ADDENDUM NO.	**1**	DATED	**2/17/2022**	ADDENDUM NO.		DATED	
ADDENDUM NO		DATED		ADDENDUM NO.		DATED	
ADDENDUM NO		DATED		ADDENDUM NO.		DATED

Number	Description
1	Revised Table of Contents; Revised NTB No. 3775; Added Notice to Bidder Nos. 3713, & 4061; Added S.P No. 907-207-2; Revised Bid Items; Revised Progress Schedule; Revised Plan Sheet Nos. 8001, 8032, 8043, 8051, 8059, 8097, 8098 & 8099; Amendment EBSx Download Required.

PROJECT: STP-0050-01(034)/106984301 - Calhoun

Bridge Replacements on SR 9 (Bridge Nos. 35.5, 40.7, 40.9 & 41.2), known as Federal Aid Project No. STP-0050-01(034) / 106984301 in Calhoun County.

SHEET NUMBER 8097

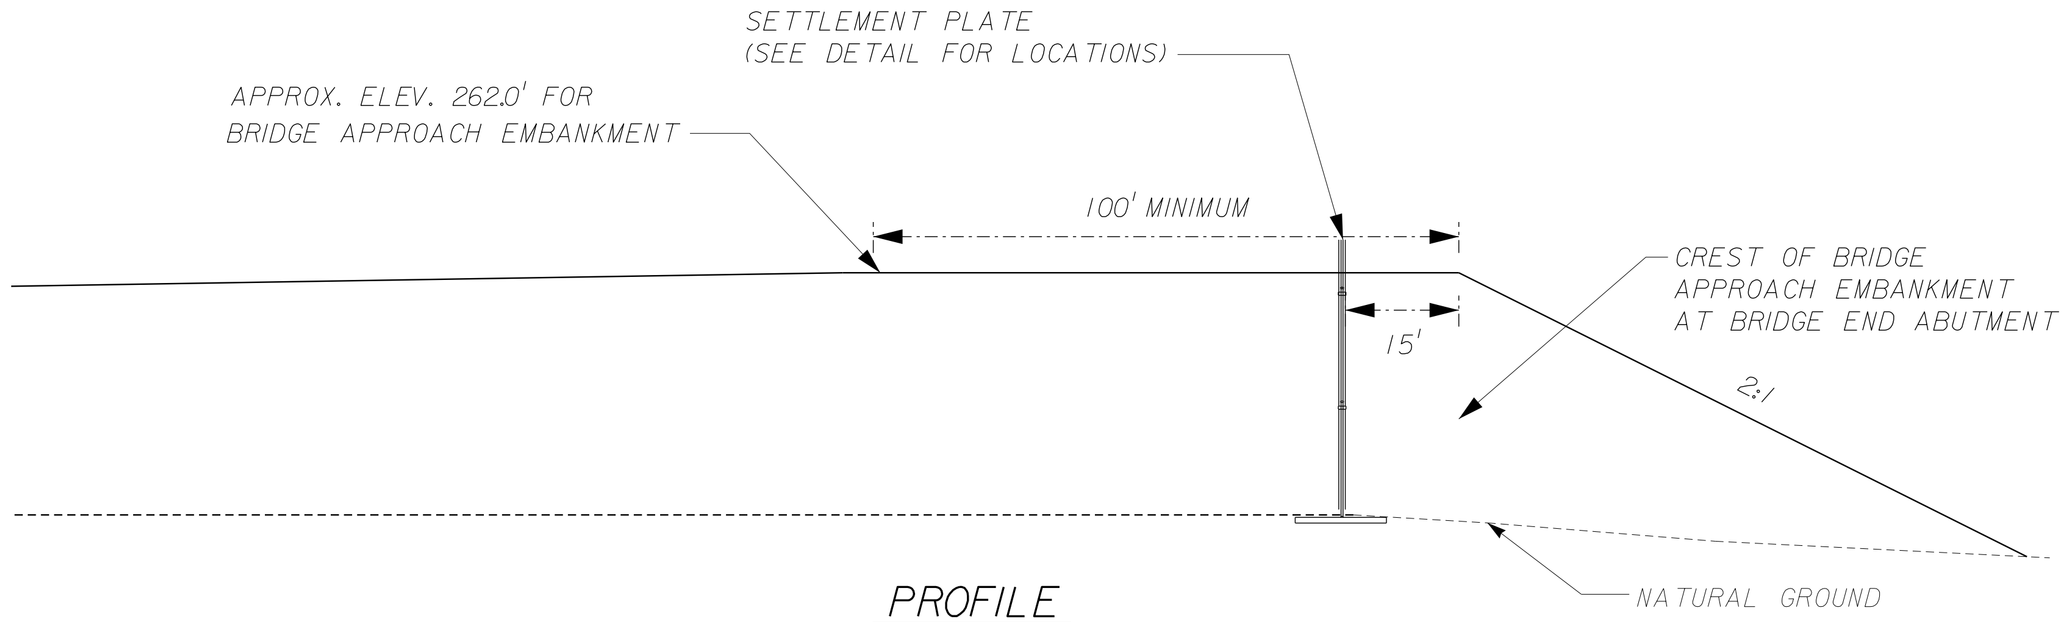
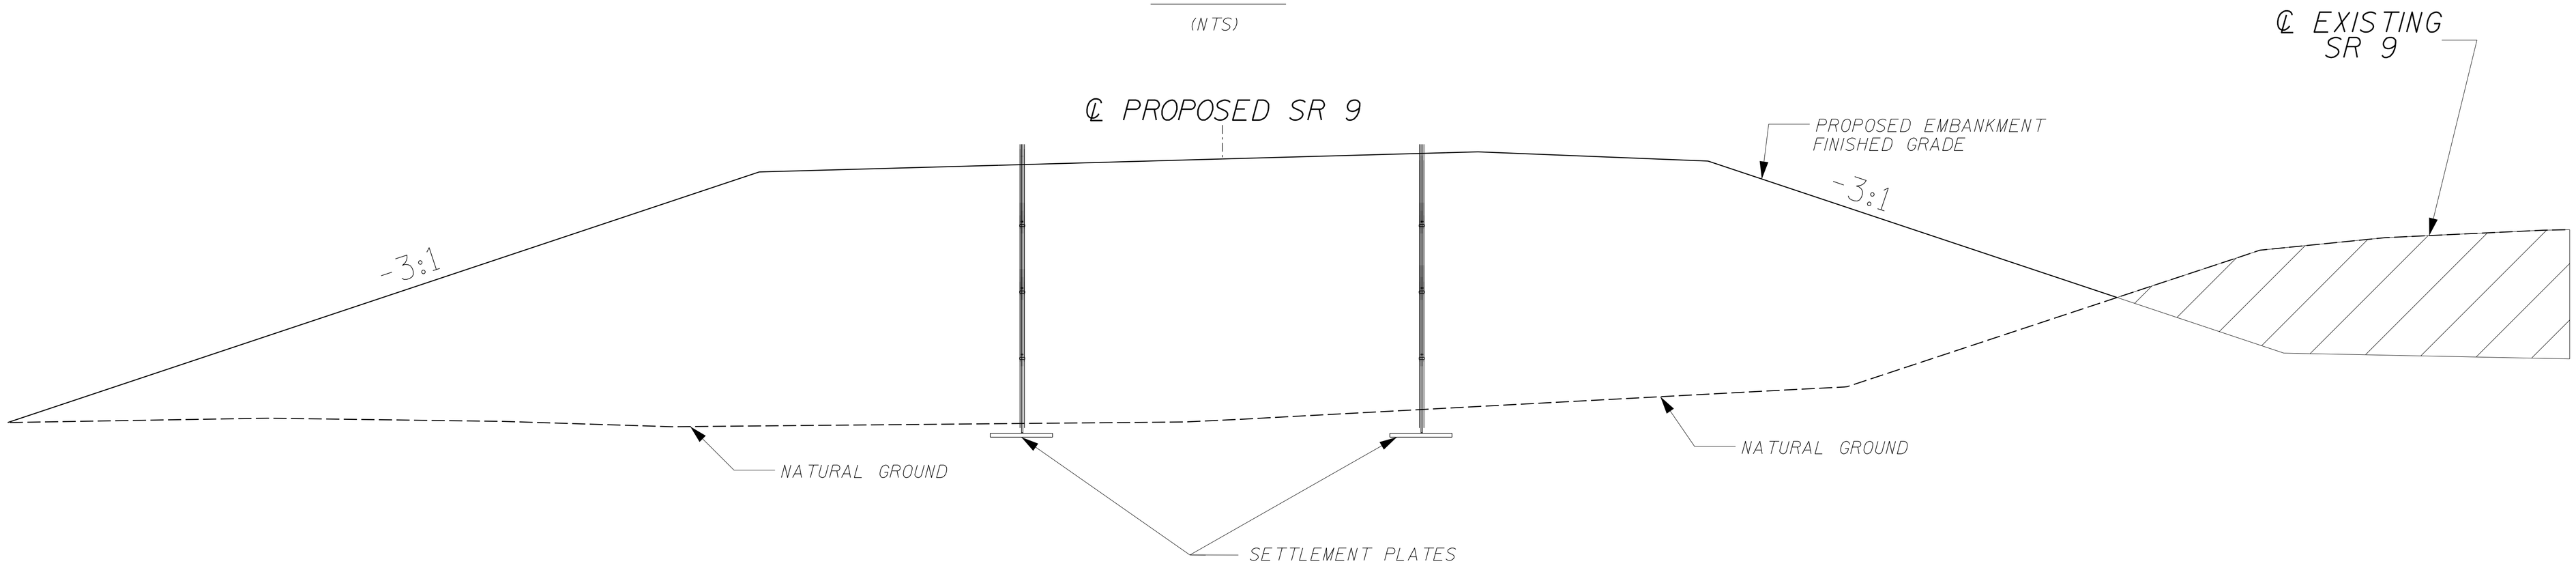
1 ADDED SETTLEMENT PLATE SHEET

BY	REVISIONS	DATE
IHL	1 ADDED REVISED SHEET	02/16/22

WORKING NUMBER: SPD-3
SHEET NUMBER: 8099

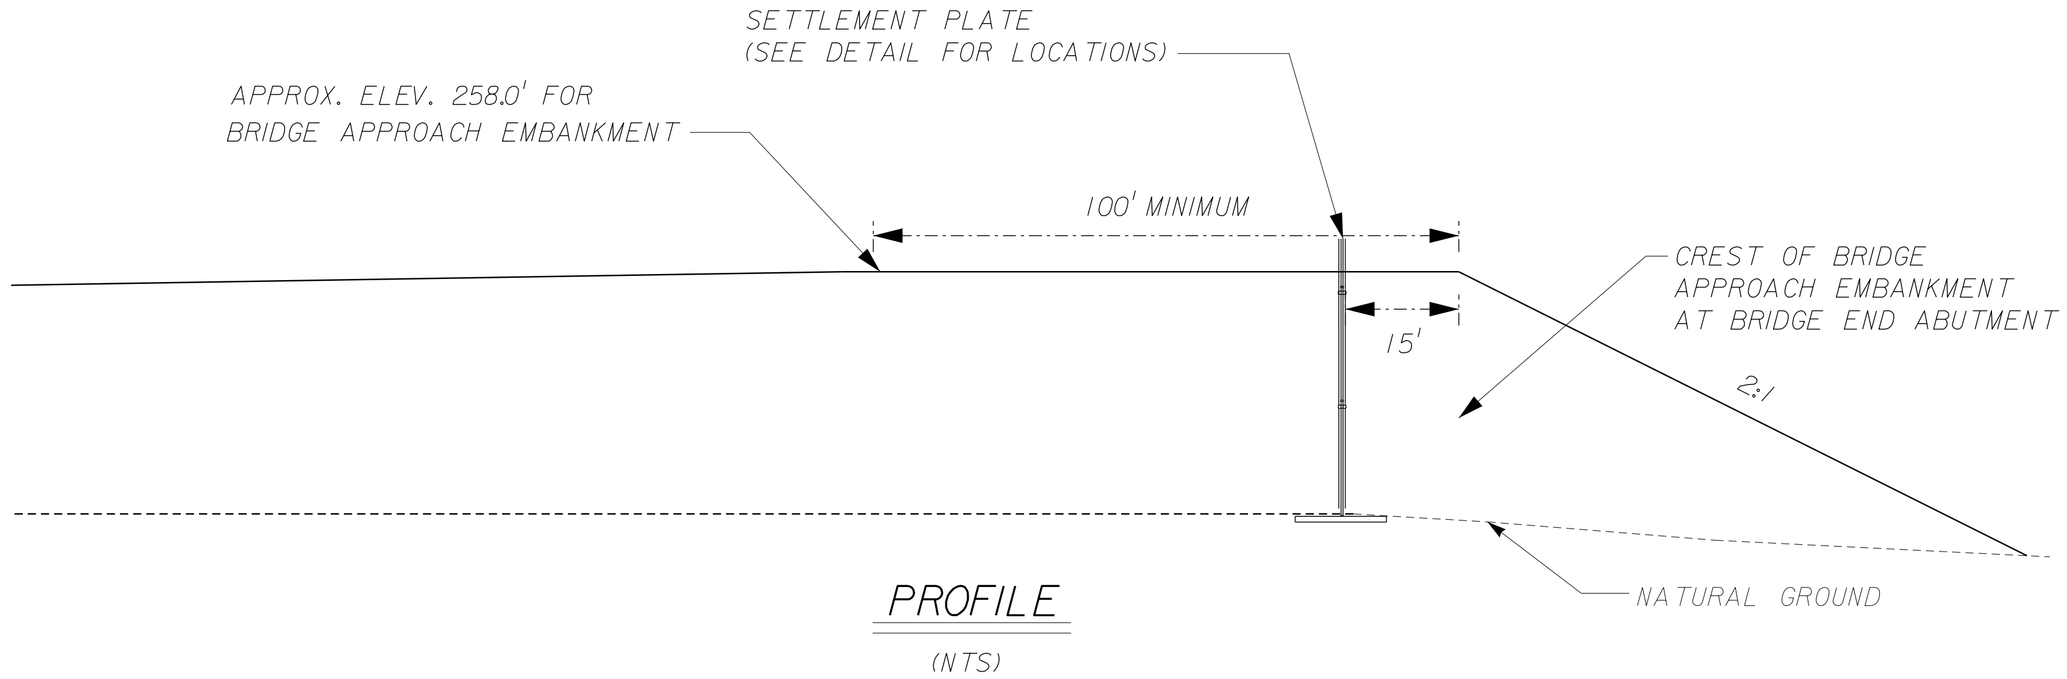
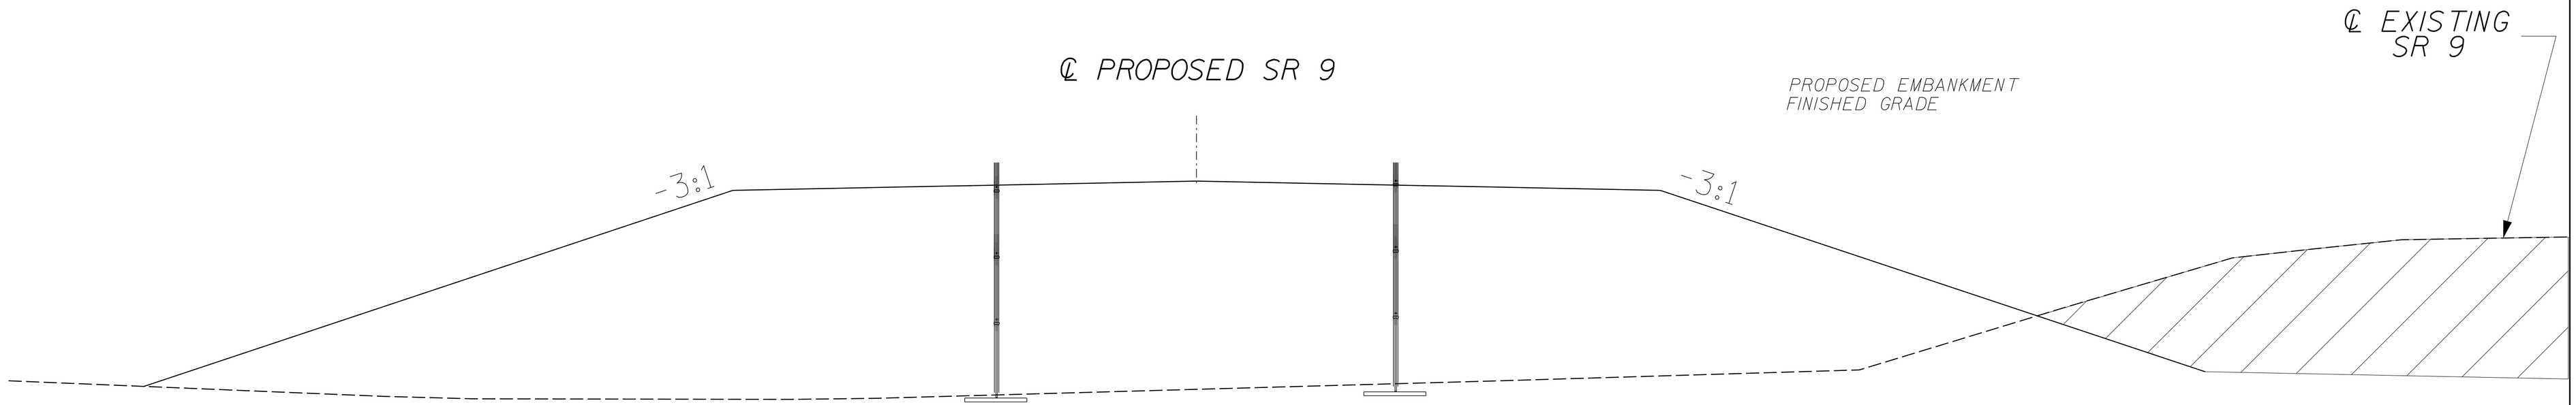
1 ADDED SETTLEMENT PLATE SHEET

ADDED REVISED SHEET	REVISIONS	BY	DATE
1		IHL	02/16/22
